VARIANCE / FIELD CHANGE NOTICE

V/F 20810-PSP-0005-07
EJK
2-20-03

PROJECT TITLE: PSP for Predesign Investigation in Area 5, Rev. 0.

FIGURE 1. BORINGS COLLECTED NEAR THE OLD FLAG POLE AND COLD WAR GARDEN.

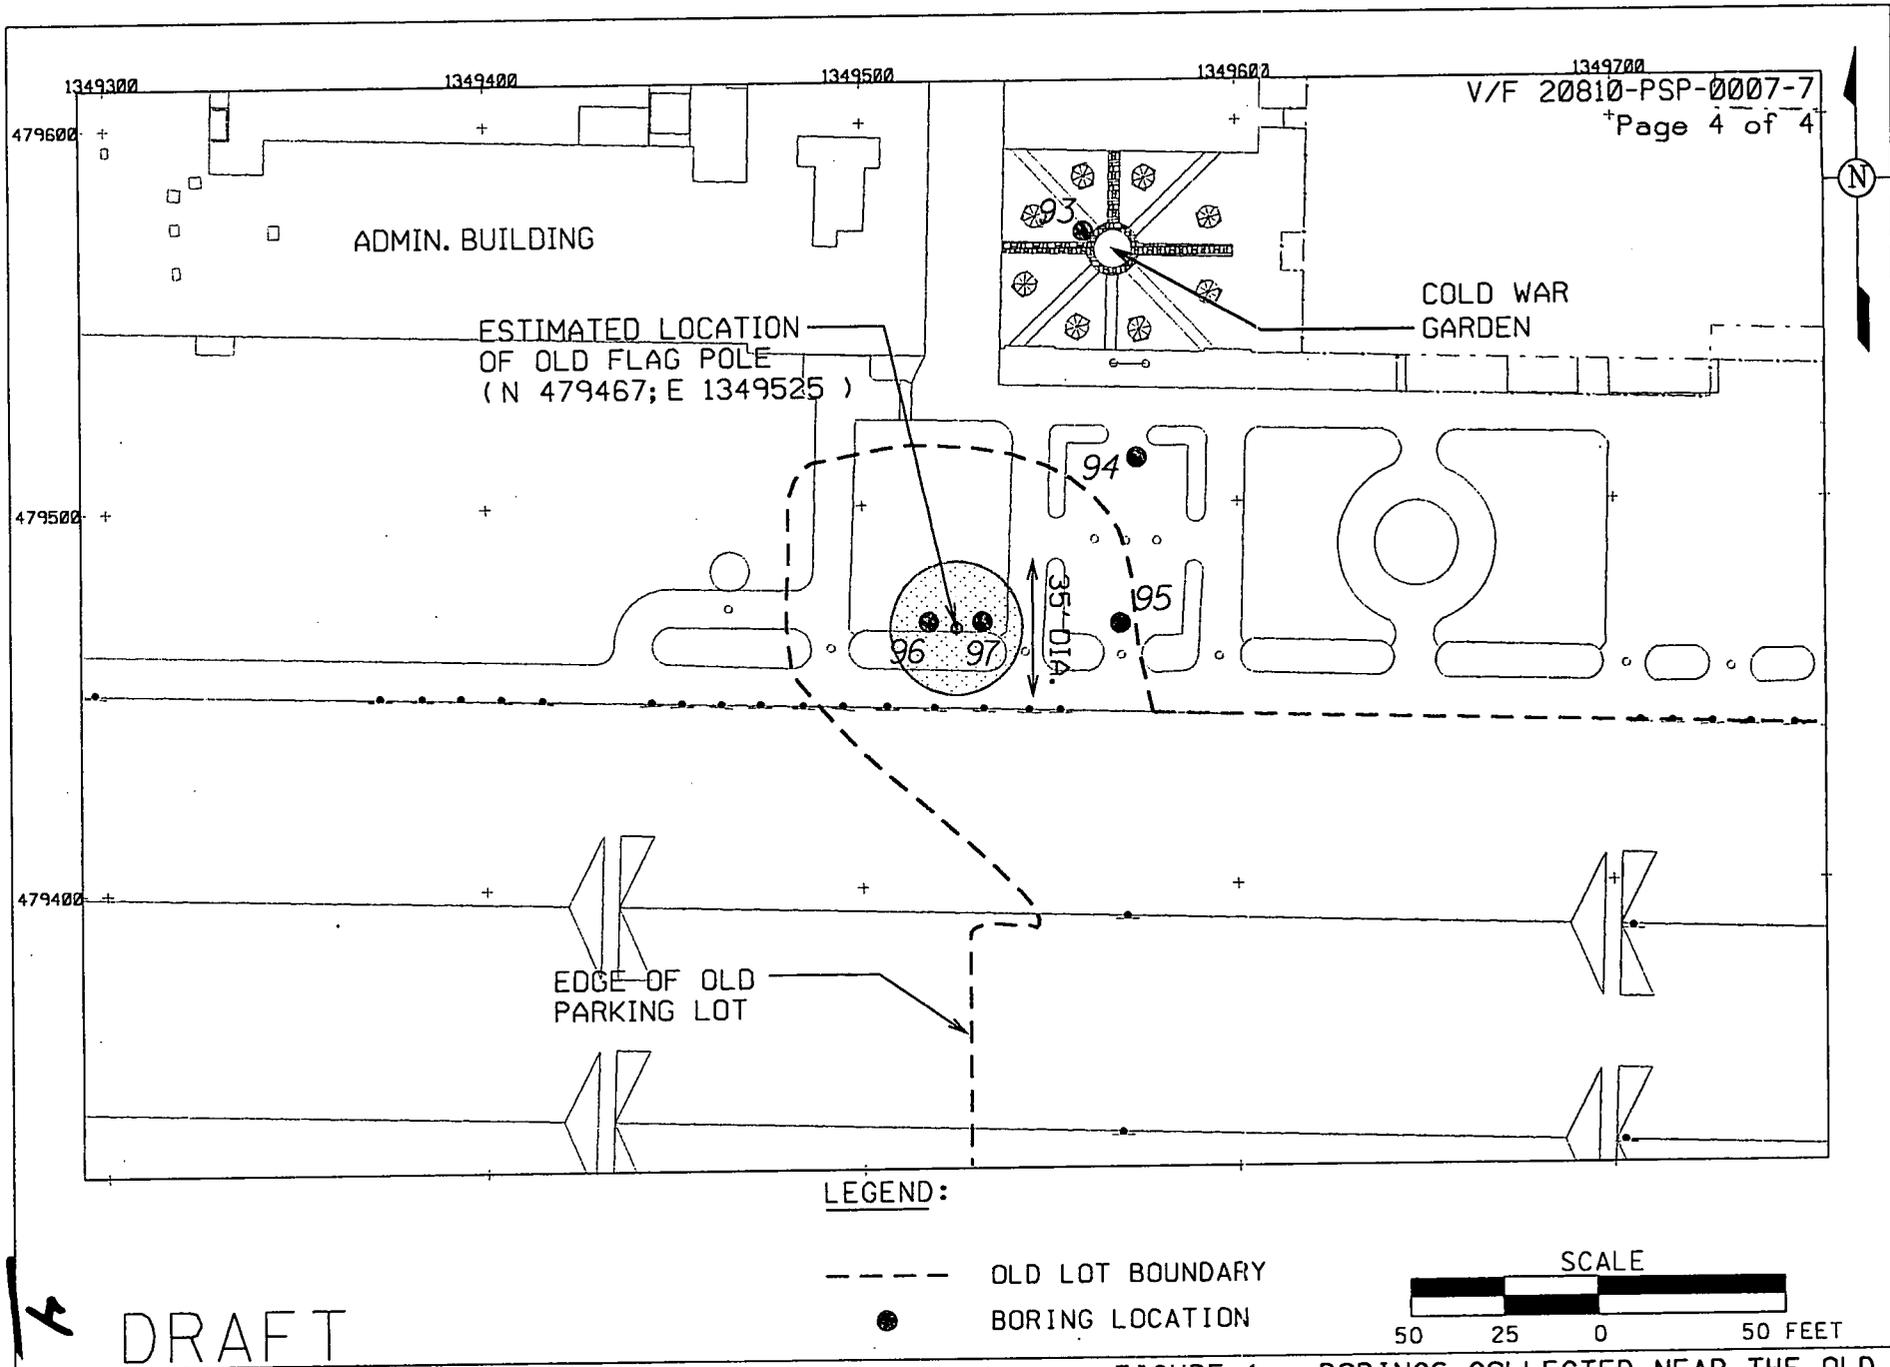
This Variance documents the collection of five borings and 10 samples from the Cold War Garden and the old flag pole location. The five boring locations are shown on Figure 1.

The three borings (93, 94 and 95) nearest to the Cold War Garden will be conducted to 2 feet below overlying material. Borings 97 and 98 near the old flag pole will be conducted to a depth of 20 feet. Upon collection per SMPL-01, all cores will be frisked with a beta-gamma frisker, and results will be recorded on the field activity log. Though not anticipated, any sample increments that exceed 450 ccpm will be considered potential above-WAC material, and they will be separated, containerized, and submitted for on-site total uranium analysis (TAL E).

For all 5 borings, the first 0-0.5 feet of soil beneath overlying material, as well as the 1.5-2 foot interval below overlying material, will be separated from the cores. The samples will be identified as: *Remediation Area-sequential #RMP*, where:
